IBC — Fire Safety

2018 GROUP A PUBLIC COMMENT AGENDA

2018 Public Comment Agenda

Figure 706.5.1(3)
EXAMPLE OF METHOD 2

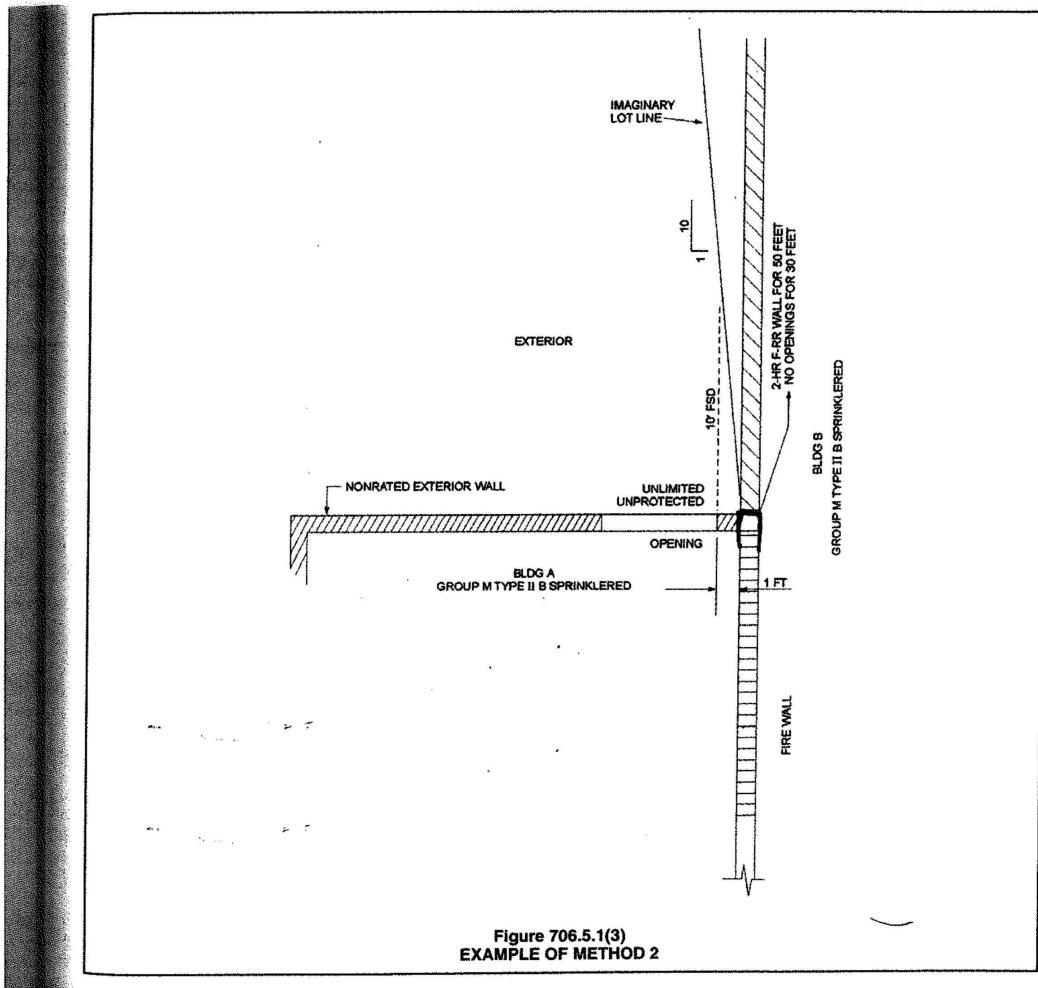
Section 706.5.2 addresses the firewall termination where the exterior walls on either side are at an angle less than 180 degrees. The first exception was removed because it makes no sense to allow this method when it would not be allowed if the buildings were separated by an inch. If two adjacent buildings are separated and joined by a fire wall and they have exterior walls that are exposed to each other at angles less than 180 degrees they should be treated as separate buildings for exposure purposes just as any two separate buildings would be treated. Current exception 1 gives you a less restrictive method when the building are touching; that makes no sense. The imaginary line exception is now a single requirement. The section was also cleaned up so it is clear how to apply the imaginary line. The current text literally states that the wall itself will assume to have an imaginary line. Walls cannot assume things. The current text also does not clearly state that the imaginary line is to be used to establish fire separation distances. Since that is not provided based on current text there is no protection requirement because section 705.5 and 705.8 are based on fire separation distance defined in chapter 2.

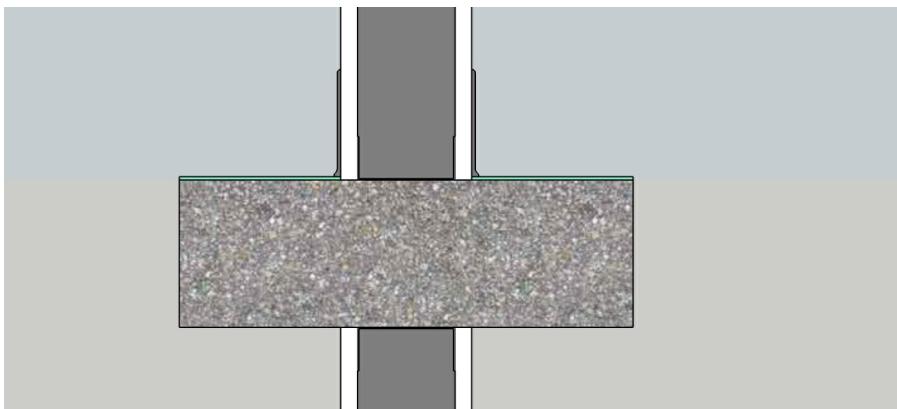
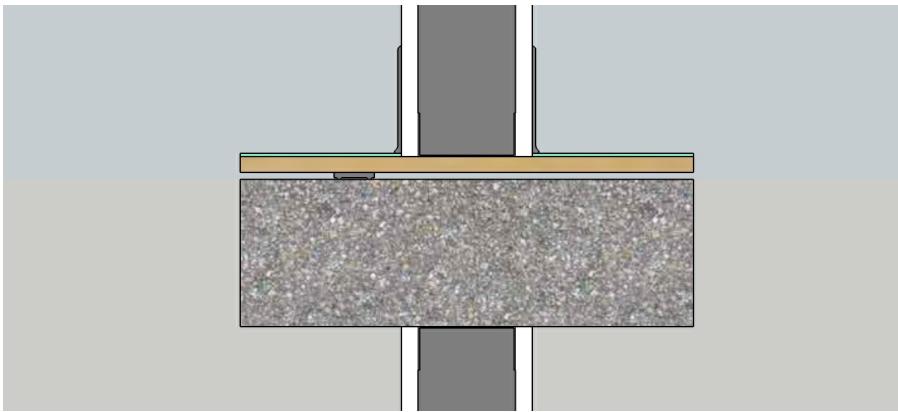
Commenter's Reason: This Public Comment supplements the Proposal and answers concerns raised at the Committee Hearings in April 2018. A definition of "interior floor underlayment" has been included. Also, a definition of "floor/ceiling assembly" is proposed since it has not yet been included in the Codes. "Interior floor underlayment" is included in the list of materials permitted in Construction Types I & II. The original proposal regarding continuity of fire partitions remains as an Exception, and includes fire protection.

Floor underlayment is not well-represented in the Codes. These commonly include luan plywood, recycled newspaper panels (Homasote), gypsum cement (Gypcrete) over polymeric filament mats (Acousti-mat), cork, recycled rubber mats (Regupol), and rubber pads supporting wood panels (Acoustic Sleeper). The majority of these systems are combustible, and they are not tested for critical radiant flux as are interior floor finishes (IBC 804).

5. Fire partitions shall be permitted to extend from the top of ~~a~~an interior floor underlayment system ~~that is not a component of the floor/ceiling assembly~~ where the building is equipped with an automatic sprinkler system installed throughout in accordance with Section 903.3.1.1 or 903.3.1.2.

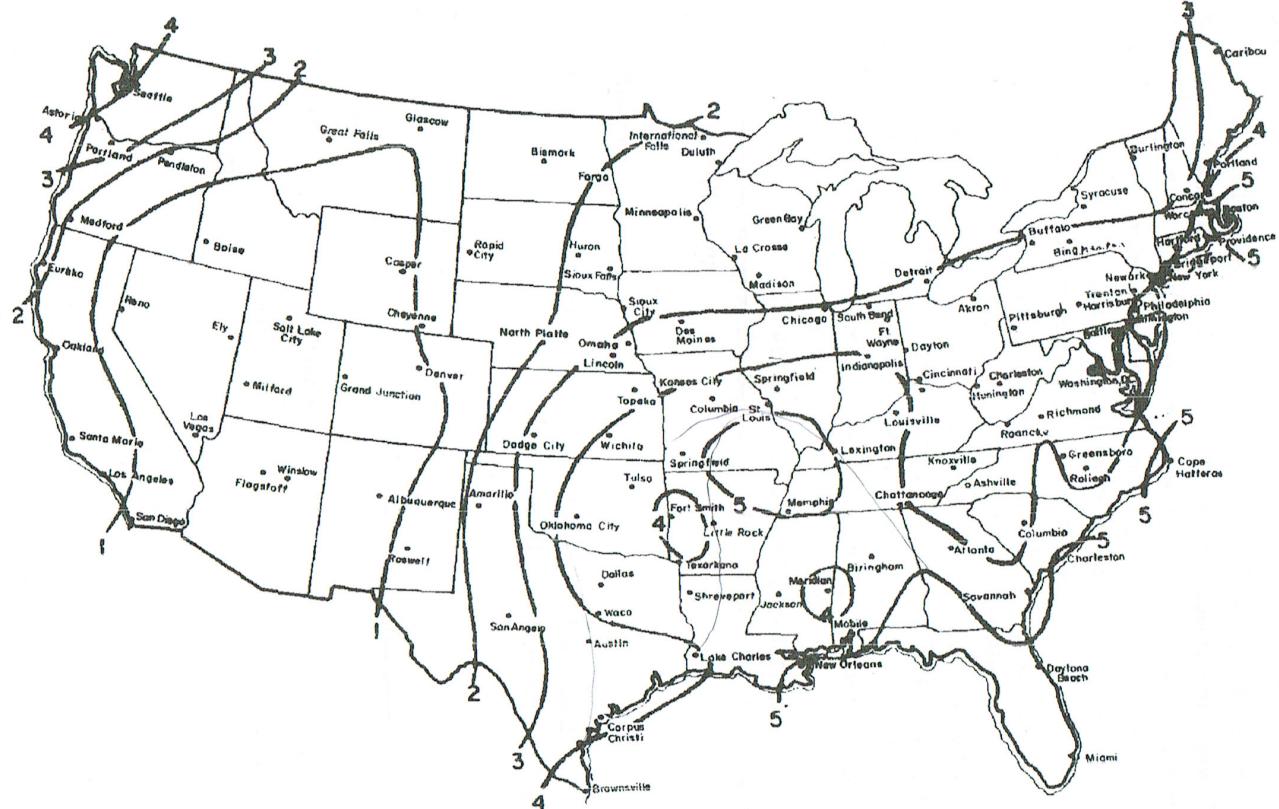
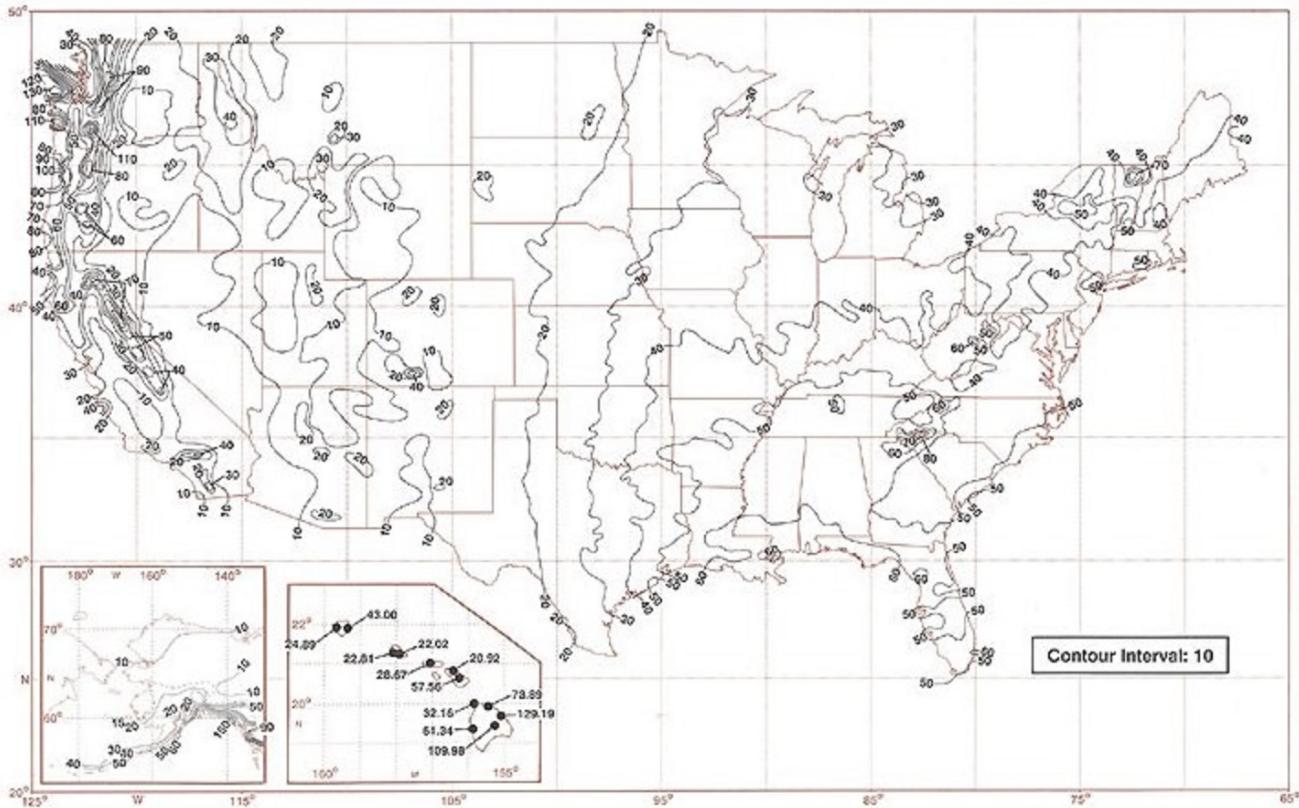
The provisions of Section 1404.5 are supported by various sources as documented in the research report ("Moisture Control Guide") referenced in the bibliography. The wind-driven rain map provided as new Figure 1404.5.1 is based on an ASTM paper as noted as the source for the figure. It is also very consistent with a more recent wind-driven rain climatology study by the University of Georgia.

1402.2.1 Extreme precipitation regions. Where the average annual precipitation amount is 50 inches (1270 mm) or greater as determined in accordance with Figure 1402.2.1 or local climate data, the means of drainage required by Section 1402.2 shall comply with one of the following:
